REPORT TO TRANSPORTATION AND ROADS COMMITTEE

Ref.:DDR/AWS/AAH/AM/6/21/2/26

Date: 10 May 1991

A96 ABERDEEN-INVERNESS TRUNK ROAD PROPOSED KEITH BYPASS

**A96 ABERDEEN-INVERNESS TRUNK ROAD
PROPOSED KEITH BYPASS**

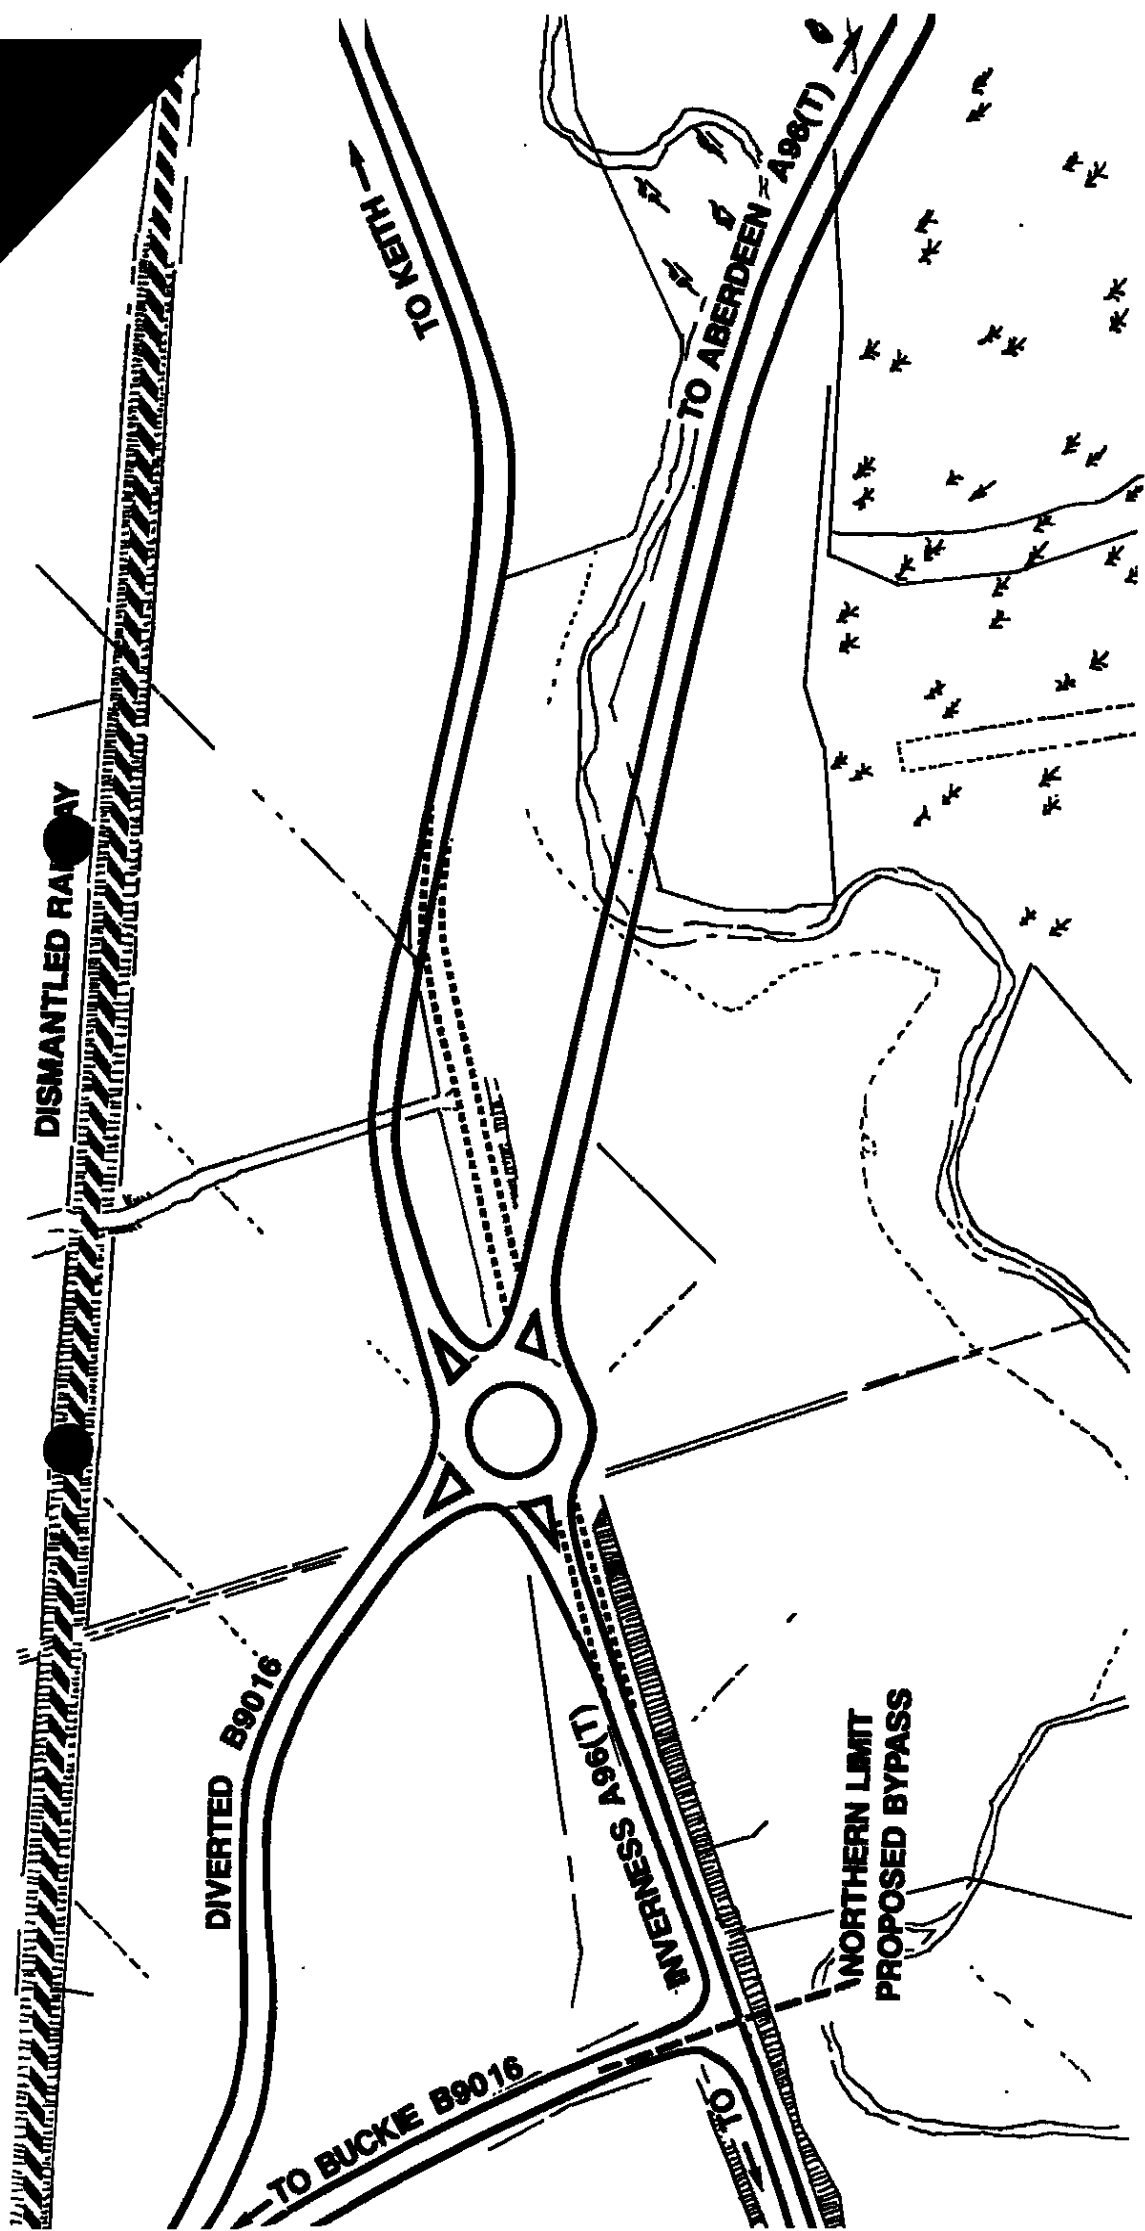
- 2.1 The Scottish Office now propose that the roundabout at the north-west end of the scheme be relocated nearer to the B9016 Buckie Road and thus linking a re-aligned section of this road into the roundabout. This satisfies the first point raised in the letter to the Scottish Office, and while the detailed design of the roundabout and the realignment of the B9016 have yet to be finalised, would seem to provide an acceptable solution. A sketch layout plan of this is appended to this report.

1. The proposed junction at the north end of the scheme should be relocated to the junction with the B9016 road to Buckie, thus extending the overtaking section on the Bypass.
